## SERVICE BULLETIN

N° **139-667**

**ATA 24 - AUXILIARY OVERHEAD PANEL AND INTERSEAT CONSOLE  
MODIFICATIONS**

This Service Bulletin is issued in order to provide the necessary instruction on how to perform the installation of the auxiliary O/H panel retromod P/N 3G2460P01021 and of the I/S console variant toll P/N 3G0630P23611.

**Figure 1**

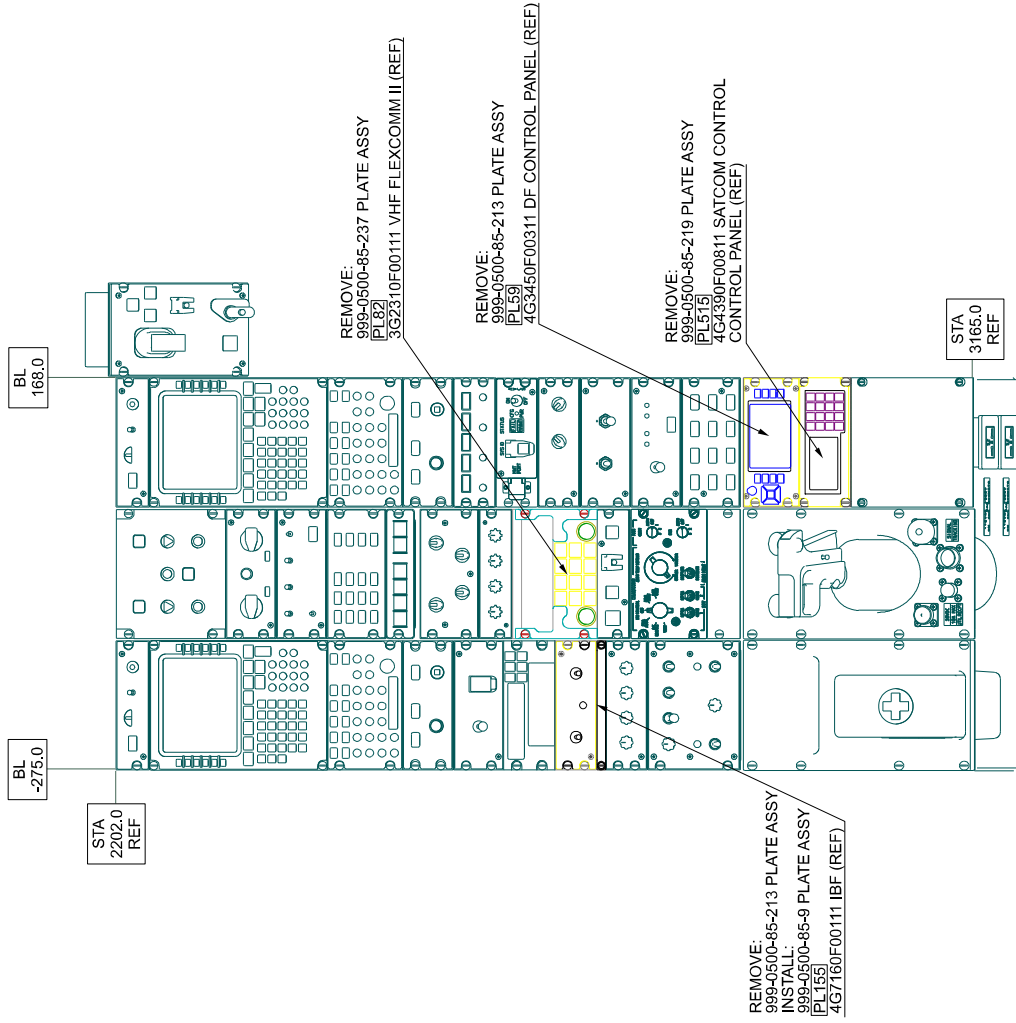
- 2.9.1 With reference to Figure 1 View Looking Down O/H Panel, Figure 2 Section B-B and Figure 4 Wiring Diagram, cut a wire P/N A556A-T20 of adequate length and lay it down between connector PL1J10 and circuit breaker CB161.

- 2.9.4 With reference to Figure 1 View Looking Down O/H Panel, Figure 2 Section B-B and Figure 4 Wiring Diagram, cut a wire P/N A556A-T20 of adequate length and lay it down between connector PL1J4 and circuit breaker CB171.

- 2.9.7 With reference to Figure 1 View Looking Down O/H Panel, Figure 2 Section B-B and Figure 4 Wiring Diagram, cut a wire P/N A556A-T20 of adequate length and lay it down between connector PL1J6 and circuit breaker CB177.

- 2.9.10 With reference to Figure 1 View Looking Down O/H Panel, Figure 2 Section C-C and Figure 4 Wiring Diagram, cut a wire P/N A556A-T20 of adequate length and lay it down between connector PL1J3 and circuit breaker CB516.

- 2.9.13 With reference to Figure 1 View Looking Down O/H Panel, Figure 2 Section C-C and View G and Figure 4 Wiring Diagram, cut a wire P/N A556A-T12 of adequate length and lay it down between terminal board TB511/2 and circuit breaker CB516.

- 2.9.16 With reference to Figure 1 View Looking Down O/H Panel, Figure 2 View G and Figure 4 Wiring Diagram, cut a wire P/N A556A-T8 of adequate length and lay it down between terminal board TB511/2 and attachment point W11A.

- 2.9.19 With reference to Figure 1 View Looking Down O/H Panel, Detail A and Detail G and Figure 4 Wiring Diagram, cut a wire P/N A556A-T12 of adequate length and lay it down between circuit breaker CB177 and attachment point W21C.

- 2.9.22 With reference to Figure 1 View Looking Down O/H Panel, Detail A and Detail G and Figure 4 Wiring Diagram, cut a wire P/N A556A-T12 of adequate length and lay it down between attachment point W22B and attachment point W22C.

- 2.9.23 With reference to Figure 1 Detail G, install Bus Bar P/N 1035685-22 (or 999-8001-73-211) by means of washer P/N NAS1149D0332K, washer P/N MS35338-138 and screw P/N NAS1802-3-7.

- 2.9.27 With reference to Figure 1 View Looking Down O/H Panel, protect the C/A E1C300 from TB511-2 to attachment point W11A with nomex sleeving P/N EN6049-006-05-5.

**Figure 2**

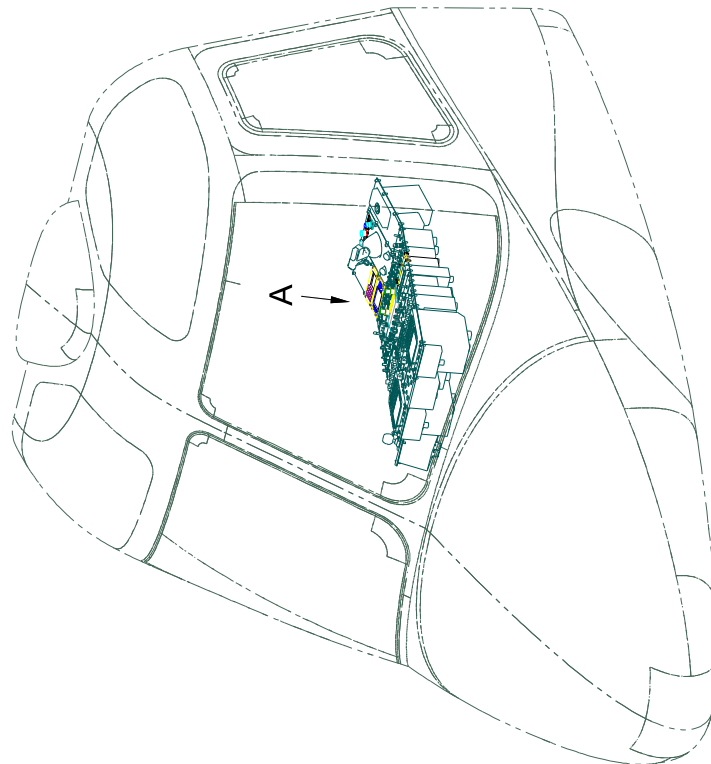
- 2.1 With reference to Figure 2 Detail D, remove n°4 lock rings P/N AW001YC01RED from panel integrally light auxiliary breaker P/N 3G2490L03966.
    - 2.2 With reference to Figure 2 Detail D and Detail E, remove the bonding cable from panel integrally light auxiliary breaker P/N 3G2490L03966.

- 2.3 With reference to Figure 2 View F, remove the panel integrally light auxiliary breaker P/N 3G2490L03966 and n°4 plugs P/N AS44417-B12.
    - 2.4 With reference to Figure 2 View F, install the panel integrally light auxiliary breaker P/N 3G2490L05755 on the O/H panel.

- 2.5 With reference to Figure 2 Detail D and Detail E, install the bonding cable previously removed on the panel integrally light auxiliary breaker P/N 3G2490L05755 by means the existing hardware.

- 2.6 With reference to Figure 2 Detail D, install n°2 circuit breaker P/N MS3320-3 and n°2 circuit breaker P/N MS3320-5 on the panel integrally light auxiliary breaker P/N 3G2490L05755.

- 2.7 In accordance with AMP DM 39-A-11-00-01-00A-720A-A and with reference to Figure 2 Detail D, install the decal P/N ED300CB161, the decal P/N ED300CB171, the decal P/N ED300CB177 and the decal P/N ED300CB516 on the panel integrally light auxiliary breaker P/N 3G2490L05755.
- 2.8 With reference to Figure 2 View G, install the terminal board stud P/N 001760-935-56, the washer P/N LN9025-0510L and the nut P/N LN9338-05.

**Figure 3**

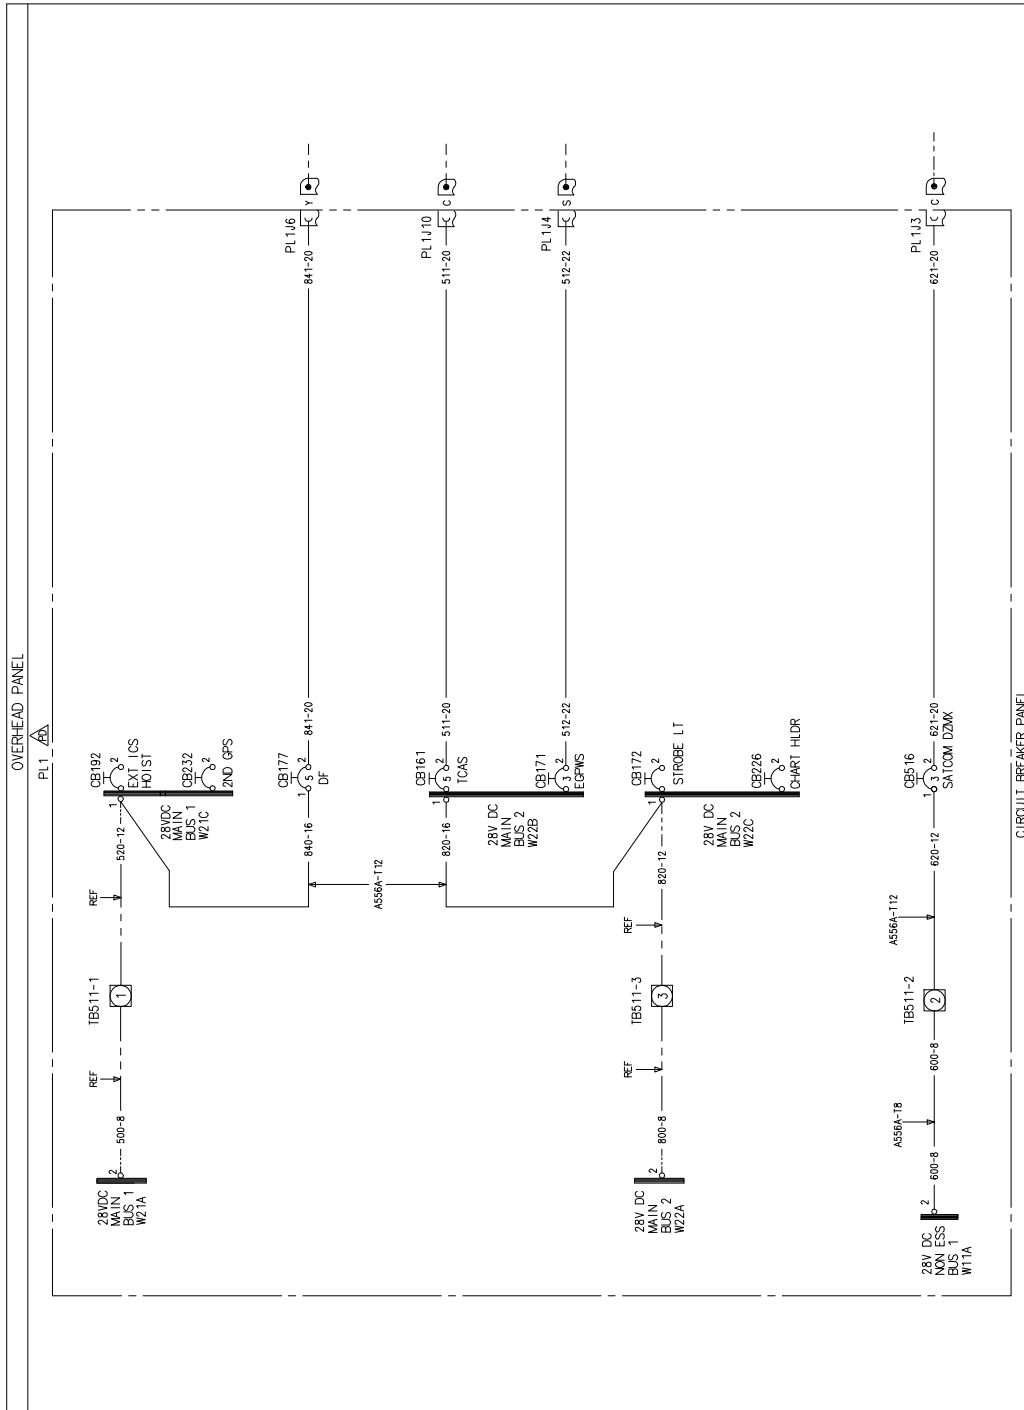
- 2.9.29 Perform a pin to pin test of all electrical connections performed.
- 2.10 With reference to Figure 3 Isometric View and View A, if necessary remove n°2 plate assy P/N 999-0500-85-213, the plate assy P/N 999-0500-85-219, the plate assy P/N 999-0500-85-237 and install the plate assy P/N 999-0500-85-9 from the I/S console.
